**BULLETIN NUMBER:**  
CB25-E-001

#### FTR FRONT STABILIZER BAR SAFETY RECALL 25V-719

(Transport Canada 2025-577)

- 2018-2026MY Isuzu FTR Vehicles

**Figure 1**

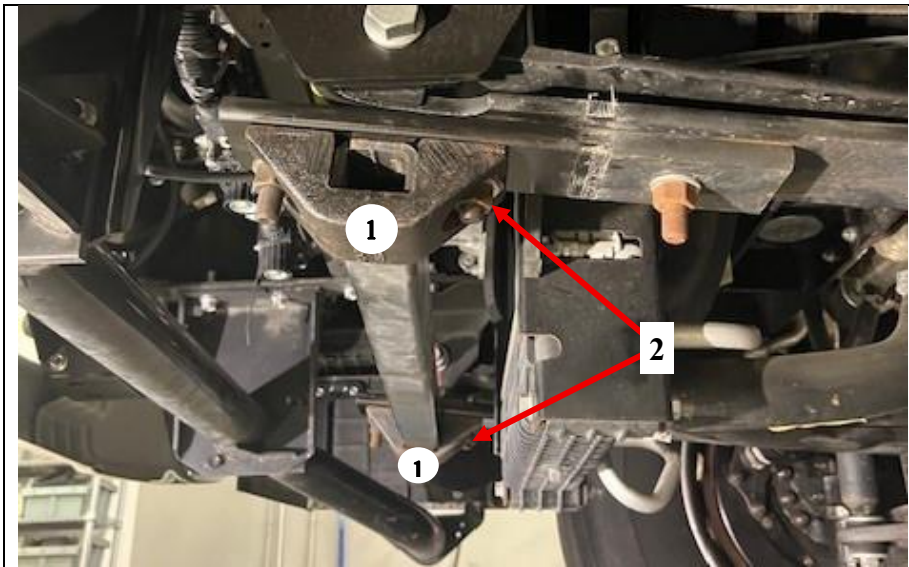
1. Spray a small amount of penetrating oil onto the stabilizer bar bracket mounting studs. This will help reduce possible damage to the mounting studs and nuts during this procedure.
2. Remove the stabilizer bar mount brackets (1) rearward nuts and washers (2). (See Figure 1.)

**NOTE: An 18mm wrench can be used to hold the stud in place if the stud spins when removing the nuts.**

Figure 2

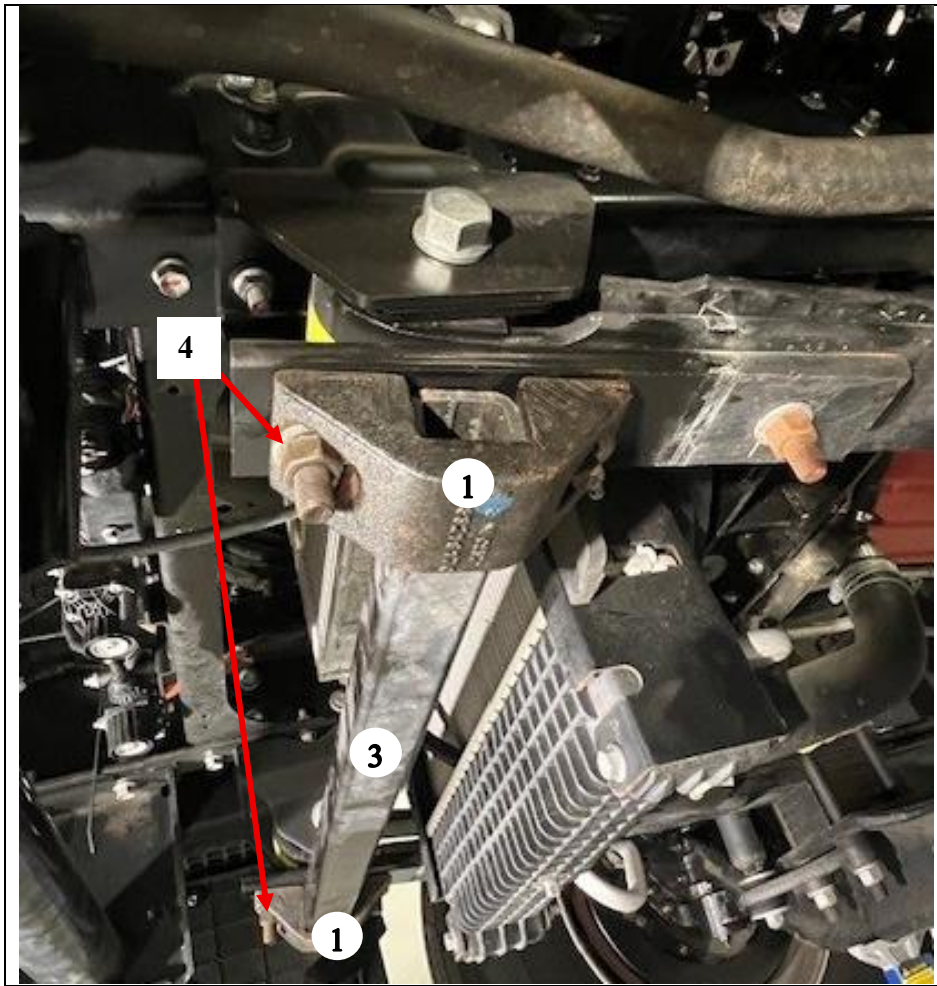
3. Support the stabilizer bar (3) and remove the remaining stabilizer bar mount brackets (1) nuts and washers (4). Remove the stabilizer bar and brackets. (See Figure 2.)

Figure 3

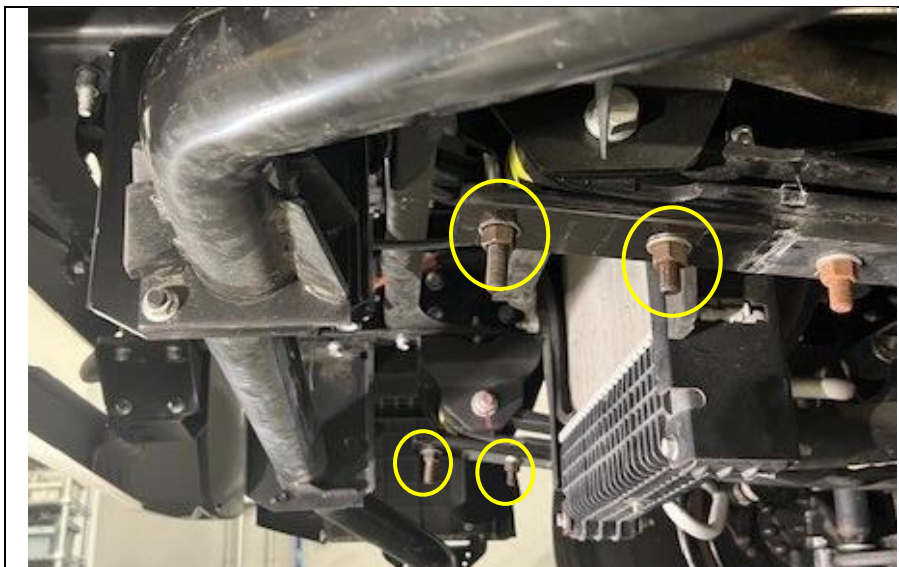
4. Clean the mounting studs to remove any debris and excess penetrating oil applied in Step 1.
5. Reinstall the original washers and nuts on each of the four stabilizer bar bracket studs and hand tighten. (See Figure 3.)

6. Tighten all four nuts (forward and rearward) and torque to 230 N•m (170 lb ft).
7. Proceed to **Applying the Campaign Label**.
